Service Kit

753-05145

Subject: Hydro Drive Belt Tensioning Idler

Models Affected: 2005 Model Year Hydro Drive 611-619 and 811-819 Series Lawn and Garden Tractors

FIGURE 2

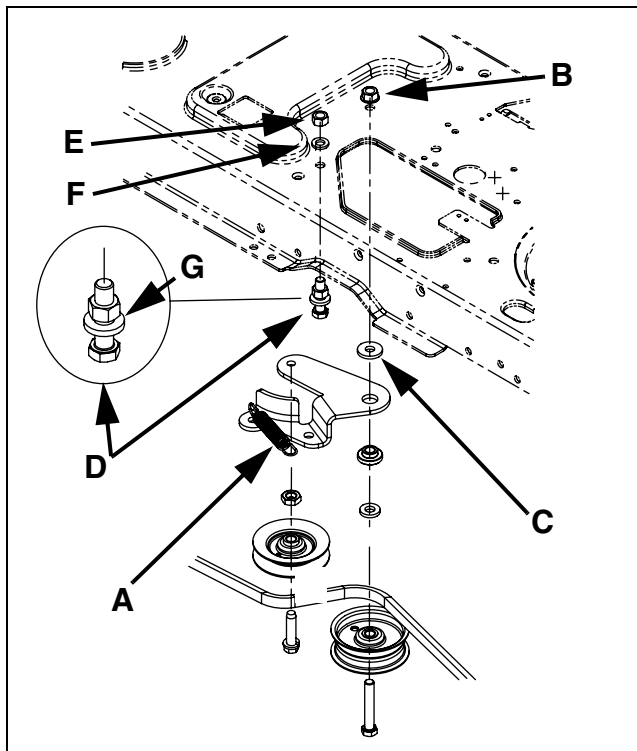
1. Under certain operating conditions, i.e. heavy loading on transmission drive, the hydrostatic transmission drive belt tensioning spring may unhook from its' bolt attachment point. This results in a loss of drive to the hydrostatic transmission. **Serial Number Range Affected: Units built between December 9, 2004 (Date Code "...L094H...") and June 21, 2005 (Date Code "...F215H...")**

2. If the tractor was built with a 736-0320 (1.38 O.D.) flat washer in the idler pivot hardware stack-up an idler rattle may be noticed during operation. **Serial Number Range Affected: Units built between December 9, 2004 (Date Code "...L094H...") and May 19, 2005 (Date Code "...E195H...")**

17. Slip the drive belt off of the fixed idler (not shown) on the left underside side of the frame. Unhook the extension spring, "A", from its' attach point at the bolt sub-assembly, "D".
18. Remove the hex nut "B" and lower idler bracket assembly.

19. Discard flat washer "C" and install new Flat Washer 736-0258, Item 2, in its place. Re-install idler bracket assembly to frame.

20. See Figure 2. Inspect spring attach bolt sub-assembly, "D", for a floating washer, "G", between the head of the bolt and the under the frame nut. If the washer is present, remove hex nut "E" and lock washer "F". Disassemble the bolt/nut/washer sub-assembly, "D" and remove the floating flat washer. Re-install the bolt sub-assembly as was originally installed less the floating flat washer.

26. Replace the existing extension spring 732-0429A with Extension Spring 732-04323A, Item 1. See Figure 2 Item "A". The spring **MUST** be hooked at the lowest point on bolt "D" (i.e. next to the head of the bolt). The orientation of the spring hooks relieves the twist in the spring when installed. The new spring also provides additional coil separation.

NOTE: If repairs were started at Step 26 there may be a floating flat washer on the spring attach point bolt "D". See Figure 2. The floating washer is not required with the new spring but can be left as is. However, the floating washer **MUST** be positioned between the spring hook and the frame.
